This Service Information bulletin supersedes SI M17 06 12 **dated September 2012.**

Service Action: Retrofit of the Engine Coolant Temperature Sensor

All with manual transmission and either the N14, N16 or N18 engine

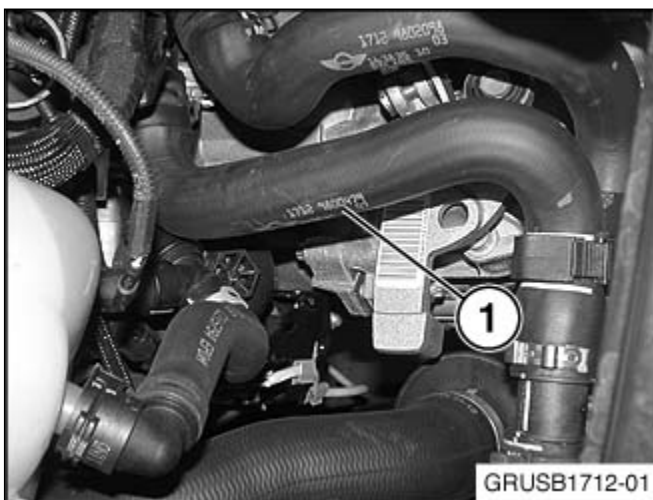
NEW Checking for the updated thermostat: The 11 53 7 534 521 thermostat has a replaceable engine temperature sensor (1).

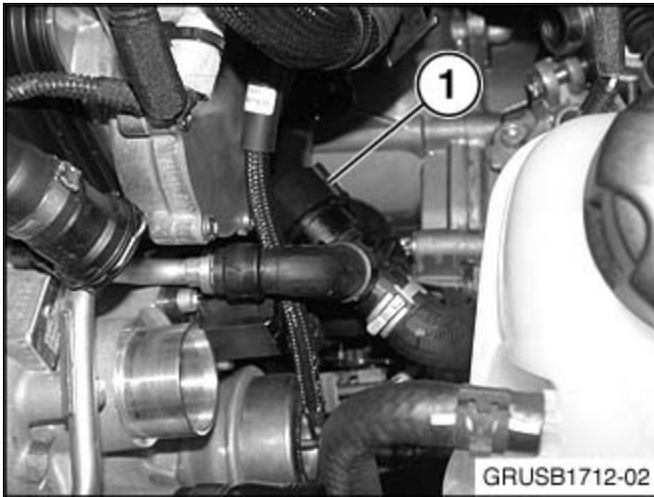
Remove the fresh air intake tube and the intake tube from the air box to the turbo to gain access to the coolant hose.

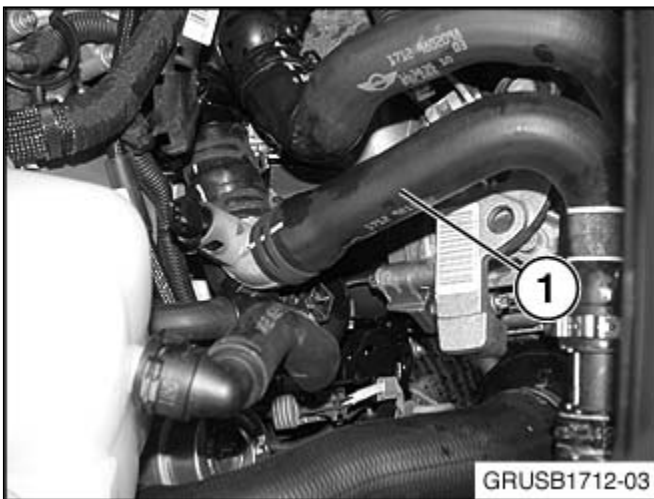
Remove the coolant hose (1). This hose will not be reused.

N18 engine only! Install spacer P/N 64 53 7 578 707 (1) on the coolant line as shown.

Note: The spacer needs to stay in this position when installing the new coolant hose P/N 17 12 7 647 004 (next step).

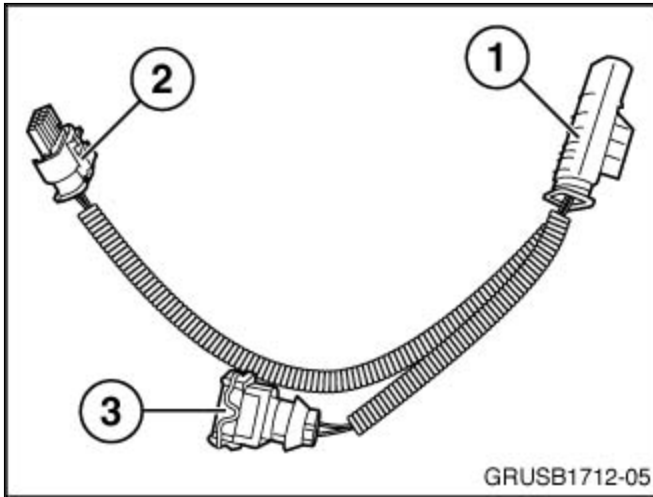
Install the new coolant hose with sensor P/N 17 12 7 647 004 (1).
